Notice of Allowability	Application No.	Applicant(s)	
	10/764,003	FARJAD-RAD, RAMIN	
	Examiner	Art Unit	
	ARISTOCRATIS FOTAKIS	2611

DETAILED ACTION

Examiner's Amendment

FIG. 3

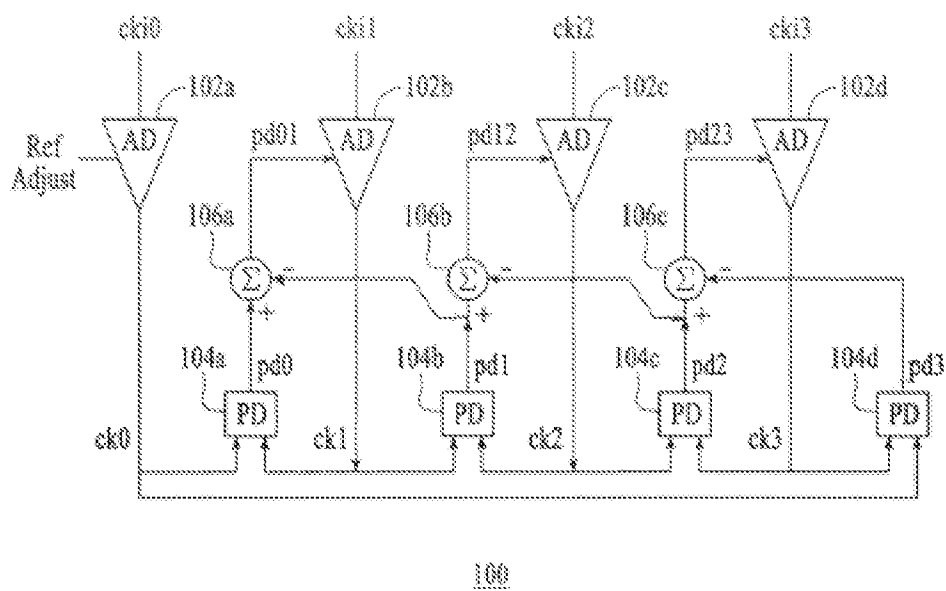
The following changes to the drawings have been approved by the examiner and agreed upon by applicant. In order to avoid abandonment of the application, applicant must make these agreed upon drawing changes. The changes in Figure 3 and 4 are shown below:
